# Upgrade Information of MPE720 Version 6.07

### 1.1 Version 6.07 Upgrade Information

### 2.1. Ver.6.07 Description

#### No.1 Bug which using one-byte katakana in the motion program comment.

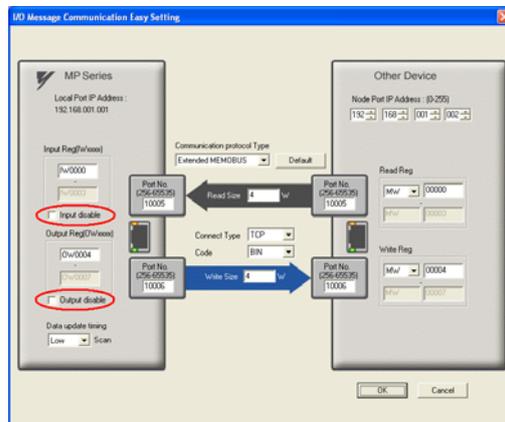
The preservation error occurred when the motion program made by using the one-byte katakana to comment of the program was compiled, and it was not possible to compile normally.

Therefore, the preservation error occurred when the motion program made before the MPE720 Ver6.05 was preserved with the MPE720 Ver6.06, and it was not possible to preserve it.

The one-byte katakana used to comment just like the version before the MPE720 Ver6.05 was done to preserve it correctly as a comment.

As a result, interchangeable data with the motion program made by the version before the MPE720 Ver6.05 was secured by this version.

### No.3 Spelling error.

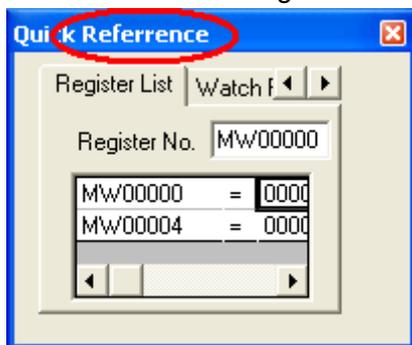
It was modified that the title was spelling error which displayed double click the Quick reference is displayed as the Engineering Manager to convert to a floating window.

It changed to a correct spelling.

### No.4 Bug of unit of display of SVB linear type for MP2310/ MP2300S/ MP2400.

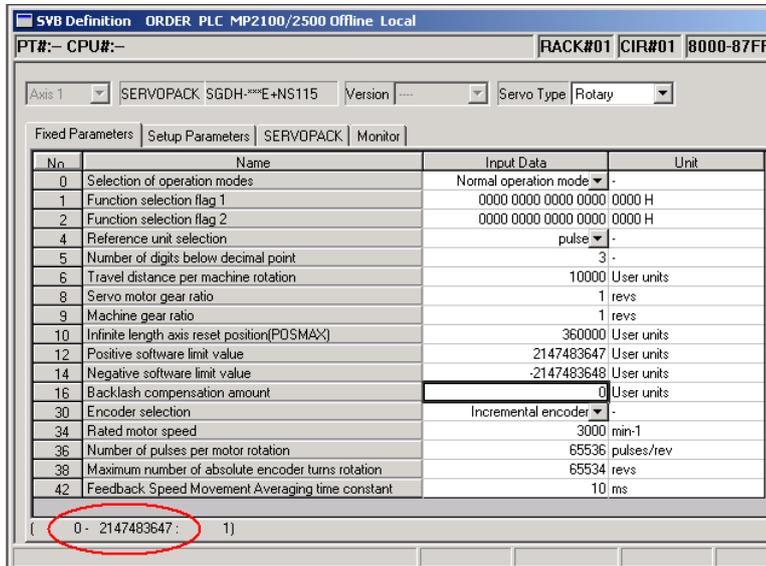
When the Servo Type of motion parameter of SVB was set in the Linear, the unit of No.6 "Linear Scale Pitch" was displayed by mistake as "microm".

And, the unit of No.34 "Rated Speed" was displayed by mistake as "0.1m/s".

The unit of the display of the parameter was made to change with the selected "user units" just like other MP2000 series.

## No.26 Bug of Save Operation that Detailed Definition of CNTR-01 Module

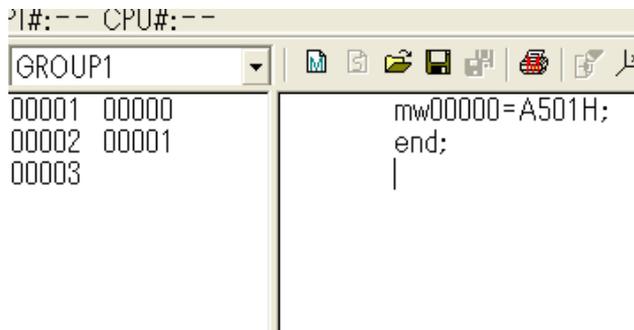
An arbitrary set value with the spin button of the Fix Parameter Set screen is changed on the screen of a detailed definition of the CNTR-01 module. And, the saving confirmation message was not displayed though it moved to the I/O Data Set screen without saving.

It was modified that the confirmation message will be displayed when data was edited at the window was switched.

## No.28 Bug of Block Number when ON/OFF is used in the Conditional Expression

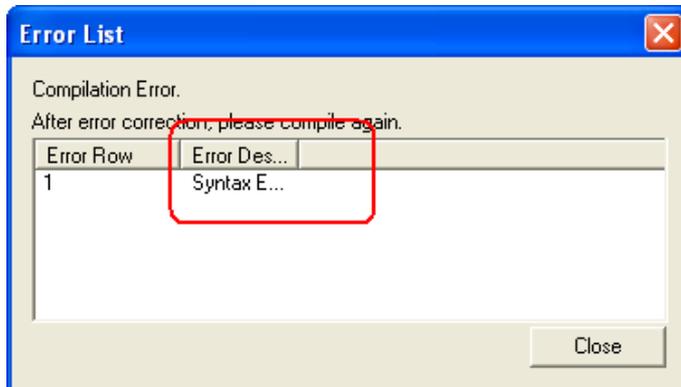
ON/OFF is described in the conditional expression of the motion program. And then, the block of an invalid empty column was created.

The block number was not made in ON/OFF instruction unit.
